*City of El Paso – City Plan Commission Staff Report*

**(REVISED)**

**Case No:** SUSU16-00026 CVS Montana Subdivision  
**Application Type:** Resubdivision Combination  
**CPC Hearing Date:** June 2, 2016  
**Staff Planner:** Vanessa Munoz, (915) 212-1644, [munozvx@elpasotexas.gov](mailto:munozvx@elpasotexas.gov)  
**Location:** North of Montana and West of Chelsea  
**Acreage:** 1.3585  
**Rep District:** 2  
**Existing Use:** Commercial and Residential  
**Existing Zoning:** R-4/SP, C-2/SP, C-2 (Residential/Special Permit)  
(Commercial/Special Permit) (Commercial)  
**Proposed Zoning:** C-1  
**Nearest Park:** Mesa Terrace (0.43 miles)  
**Nearest School:** Hillside Elementary (0.67 miles)  
**Park Fees Required:** \$1,360.00  
**Impact Fee Area:** N/A  
**Property Owners:** El Paso West Airport, Ltd.  
William & Johanna Welsh  
**Applicant:** First Hartford Realty Corporation  
**Representative:** Linfield, Hunter & Junius, Inc.

**ATTACHMENT 3**

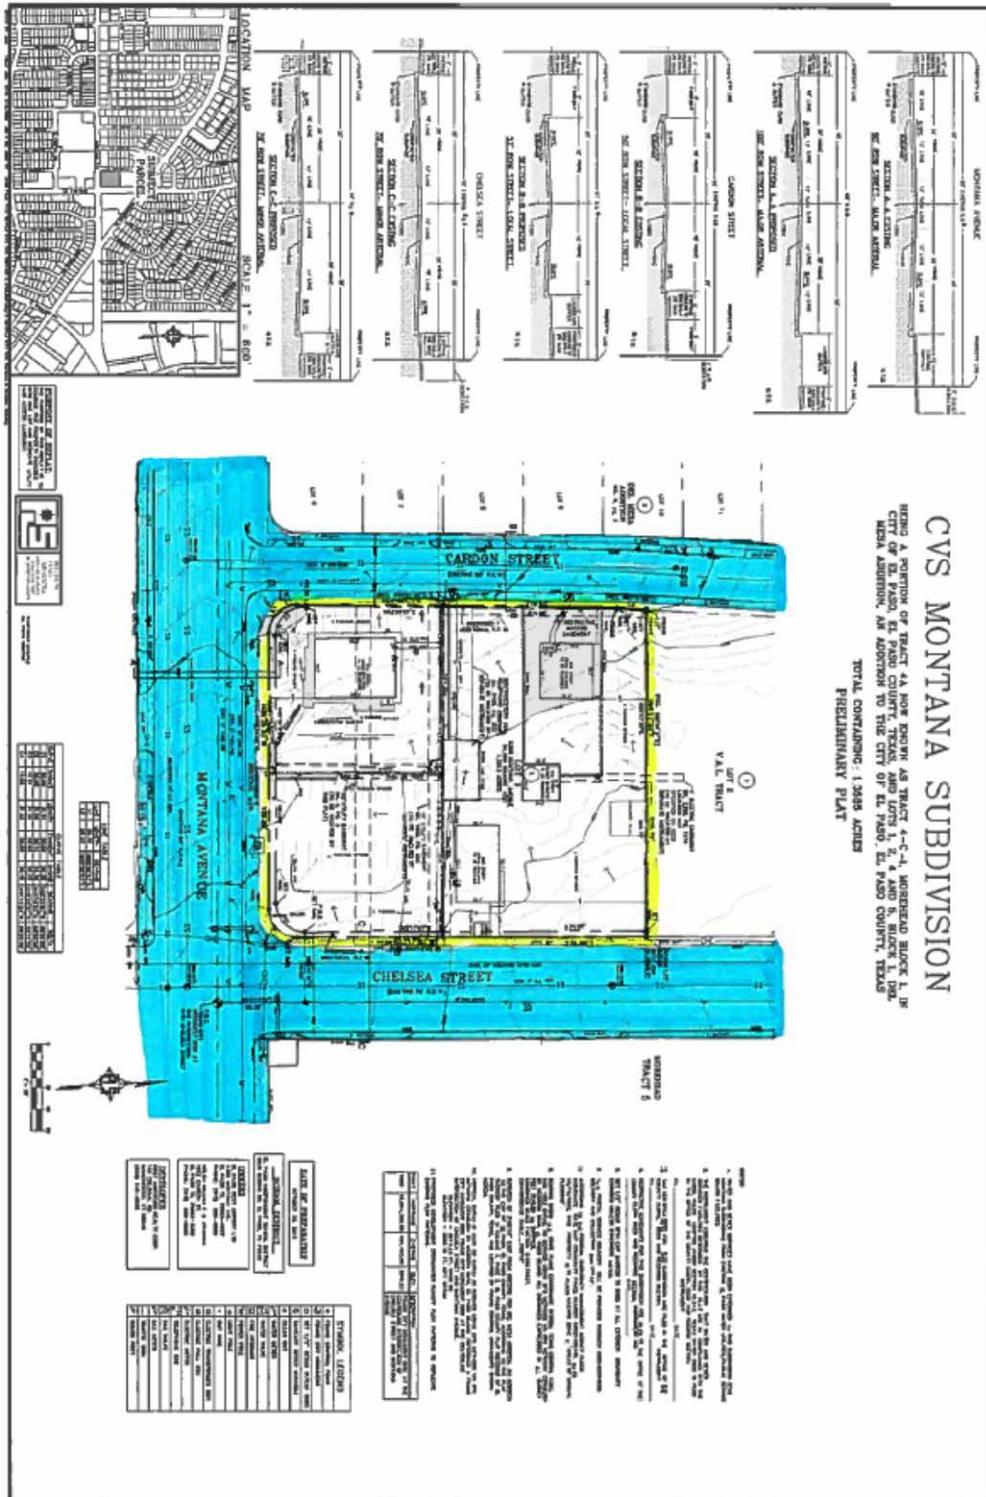
- ~~1. Show any proposed easements to be dedicated by this plat.~~
- ~~2. At the improvement plan stage, provide protection to the subdivision from all offsite stormwater runoff that may have an adverse impact on any improvements.~~
- ~~3. Proposed ROW improvements must not encroach into private property line. Proposed~~

~~sidewalks for Cardon and Chelsea must be built abutting property line.~~

1. No objections.
